### PLANNING COMMISSION MEETING STAFF REPORT

The Village

Master Plan

Subject: The Village Development - Master Plan Review

LUSTER THE VILLAGE OPEN SPACE PLAN

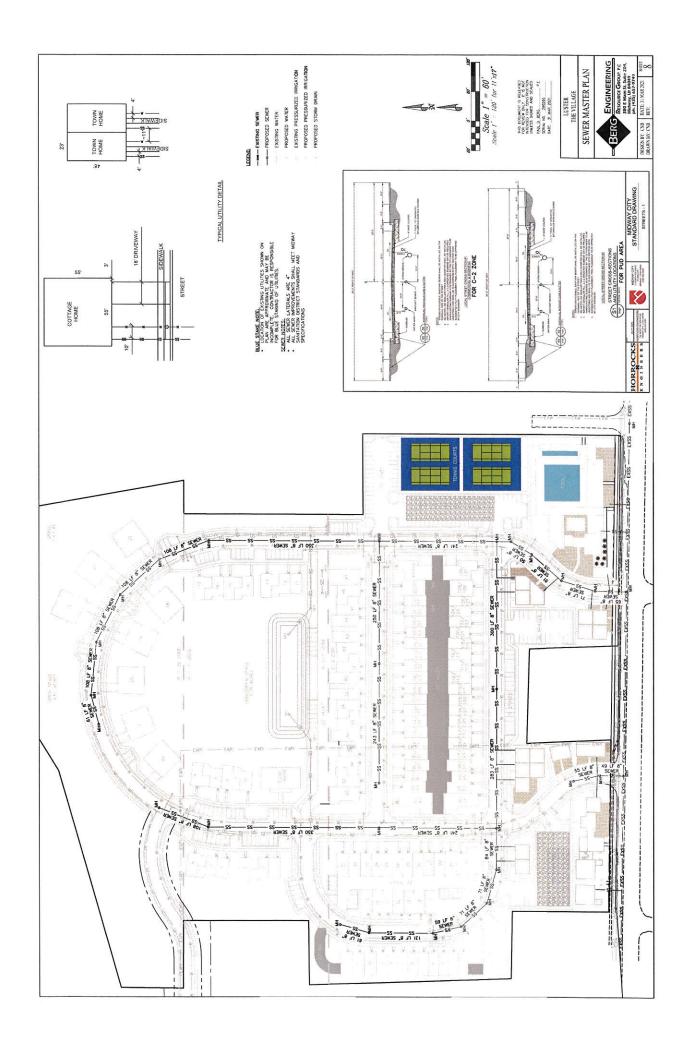
Open Space – The proposal has no required open space except for the area of the PUD where 50% is required. The application indicates that the PUD has 55% open space as presented on the Open Space Plan (please see attached). The code requires that with each phase there is enough open space to comply with the 50% requirement of the code. If phase I has 75% open space, then phase II only needs to have 25% open space if both phases are equal in acreage. Since some of the units included in the PUD are in phase 3, some of the open space currently planned for phase 6 will need to be dedicated as part of phase 3.

- 1. Open space is dedicated as part of phase 3 to comply with PUD open space requirements.
- 2. Groundwater must be addressed to assure the below grade parking areas and basements are feasible.
